**Date:** March 5, 2021  
**To:** Zoning Committee of the Saint Paul Planning Commission  
**From:** Mike Richardson, City Planner  
**Subject:** Second Update on Zoning Case 21-225115, James and Lexington Apartments

## ZONING COMMITTEE STAFF REPORT

**FILE NAME:** James Avenue Apartments

**FILE #:** 21-225-115

**STAFF FINDINGS LOCATION DIAGRAM**

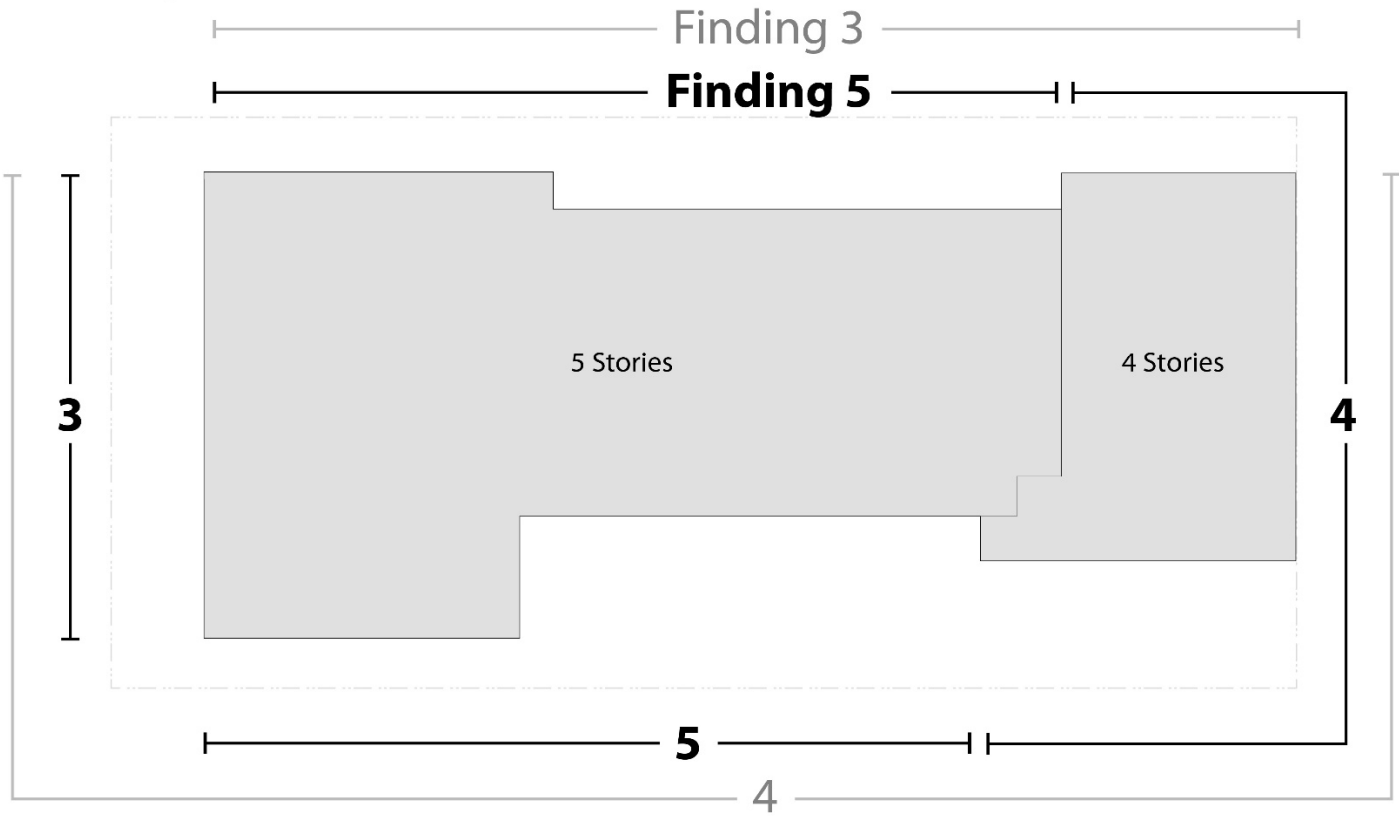
1. The Applicant agreed to reorient the building so that its front yard now faces Lexington Parkway instead of James Avenue. Reorientation will change the building's yard designations and therefore the required yard setbacks. A 25' minimum setback will now apply to the Lexington side of the building but the variance on the James side will be reduced.
2. The Applicant and staff worked to determine more precise height measurements, which reduced the height request and dependent side-yard setback requirements.
3. The Applicant has shifted the building to the eastern property line to increase the setback distance on Lexington Parkway.
4. Staff has revised its report and some recommendation based upon changes brought about by the building's reorientation, shift to the east, and updated measurements. See page 2 showing how findings are organized in the updated staff report.

VARIANCE REQUESTS

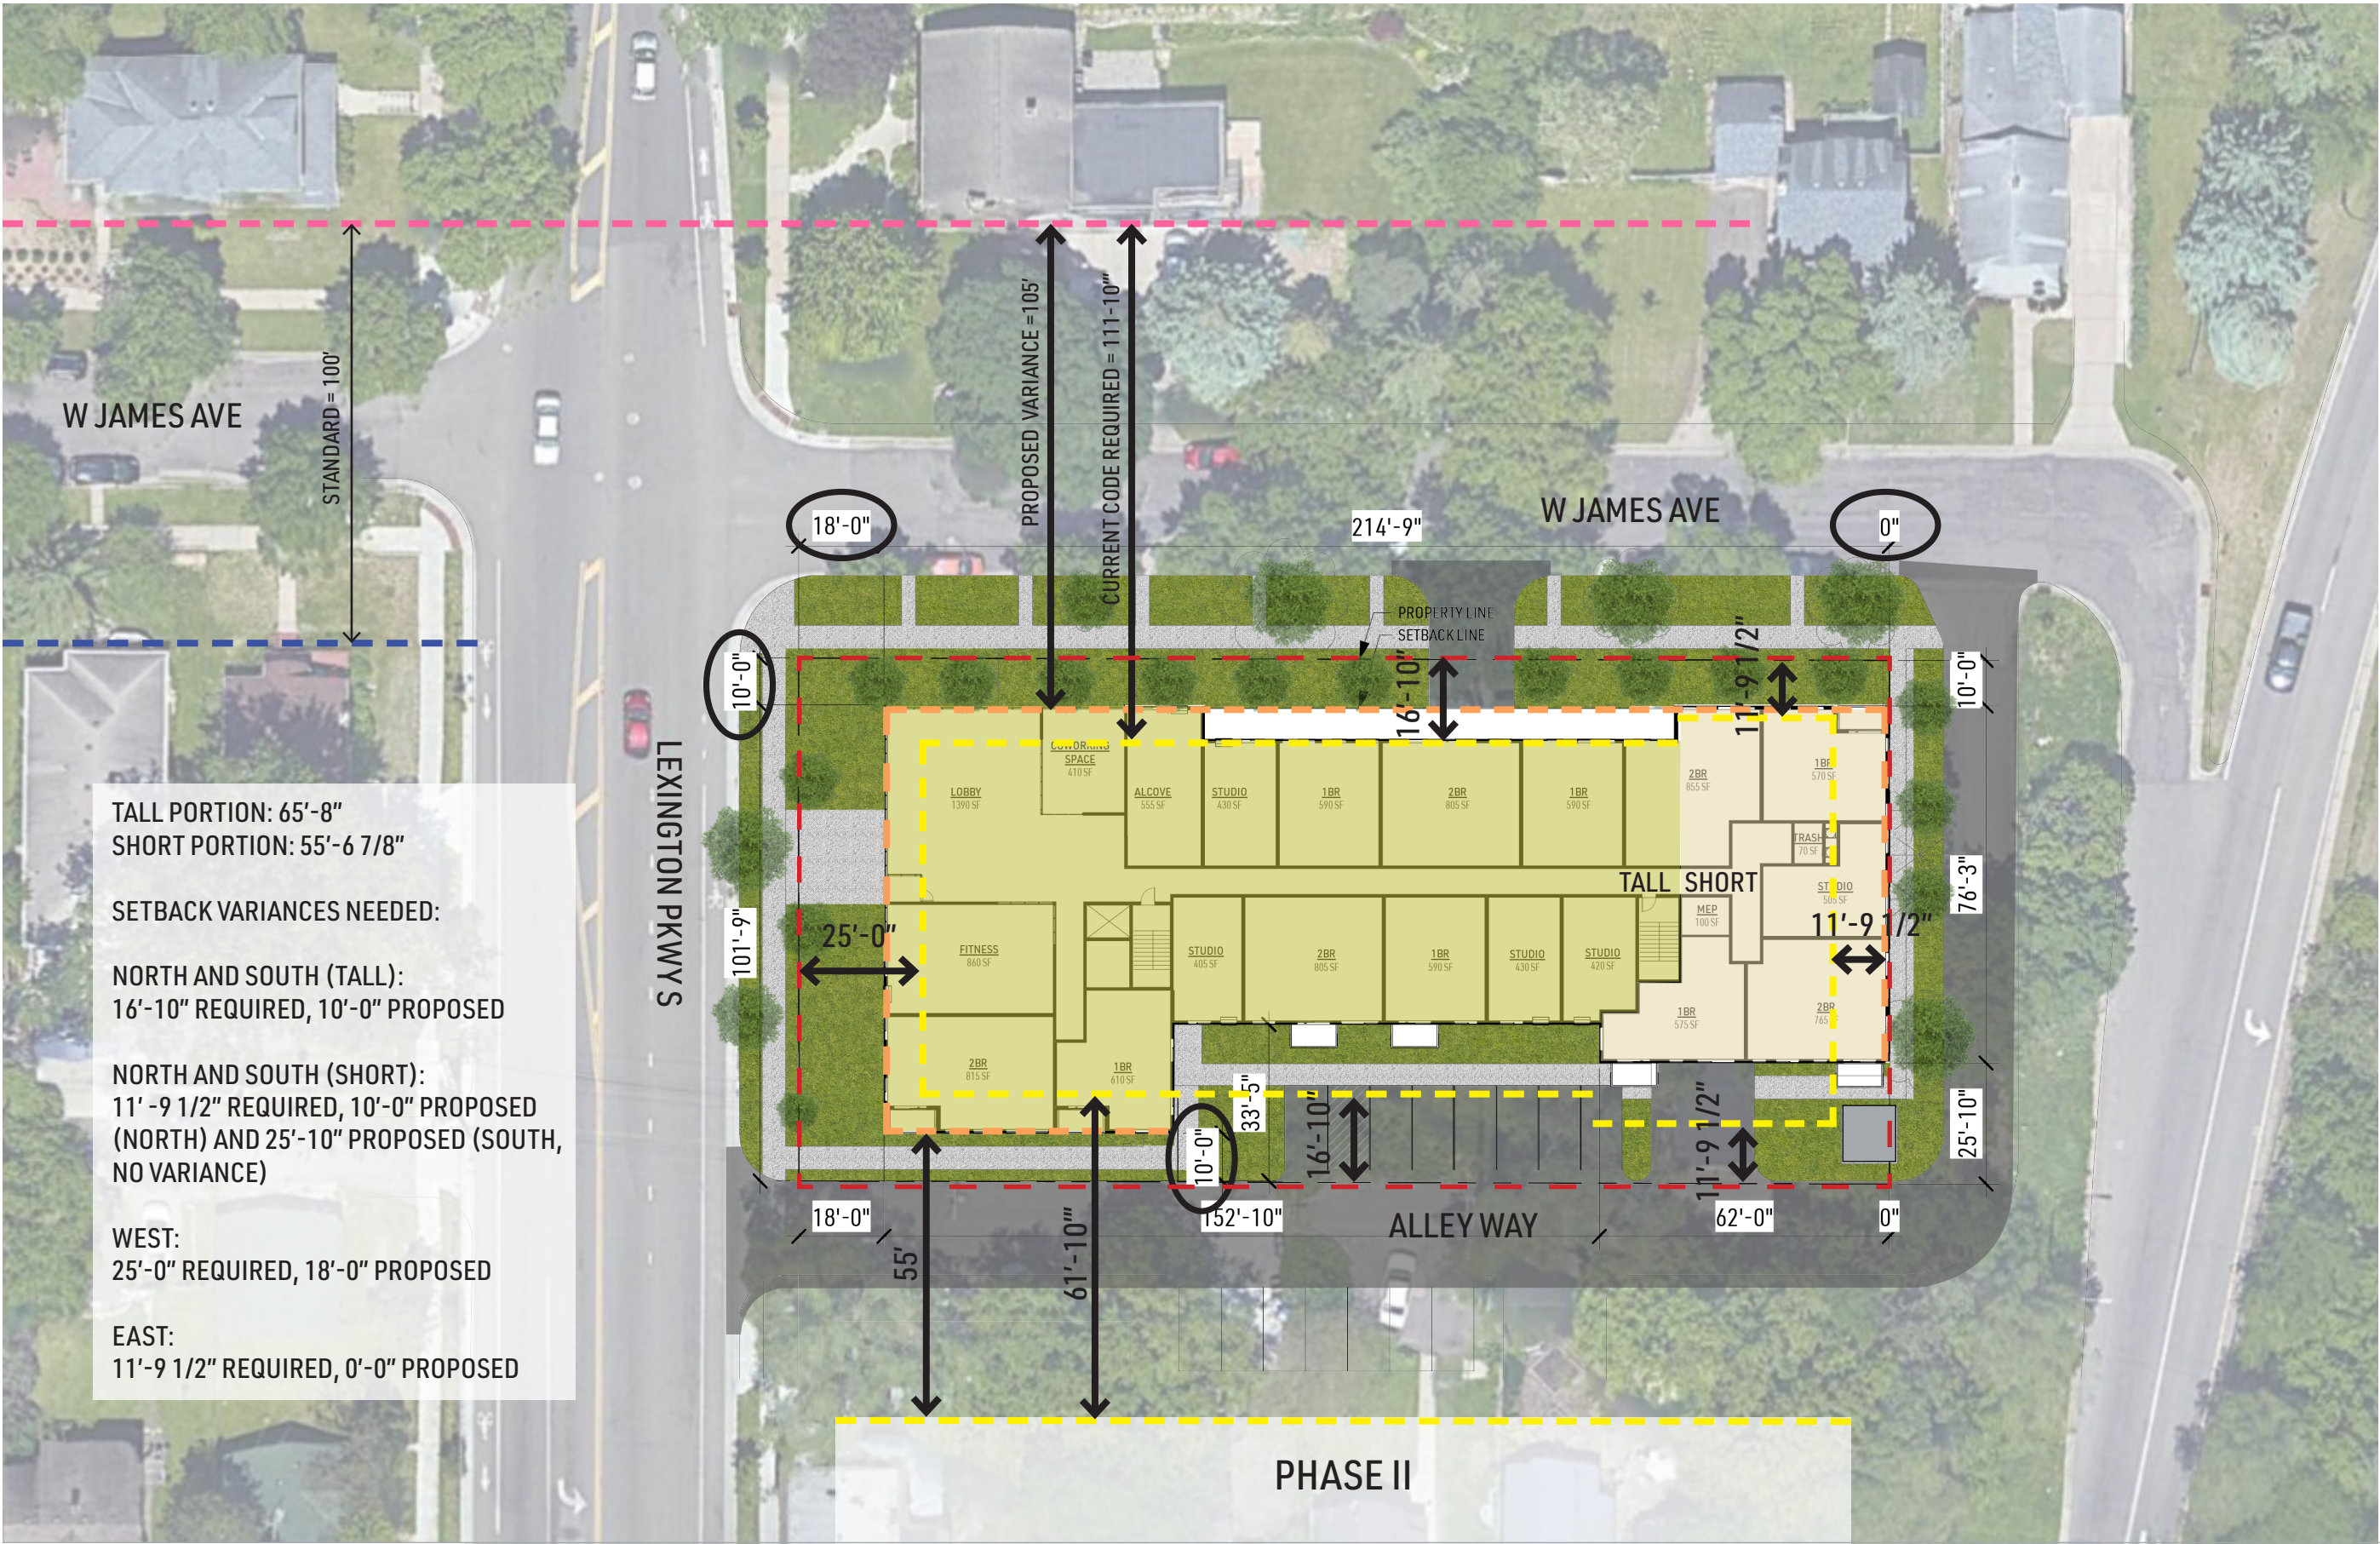
- ***The front of the building, which was previously James Avenue, would be revised to Lexington Avenue, which would require a twenty-five (25') setback from the Western property line.***
- ***The building would be (pushed) placed on the Eastern property line.***
- ***The average height of the building would be recalculated.***
- ***A new set of variances would be requested along with a revised CUP for height, see below.***

- ***North - 16'-10" required - 10'-0" proposed***
- ***South - 16'-10" required - 10'-0" proposed***
- ***East - 11'-9.5" required - 0'-0" proposed***
- ***West - 25'-0" required - 18'-0" proposed***

- ***Required height 50'-0" - 65'-8" proposed***
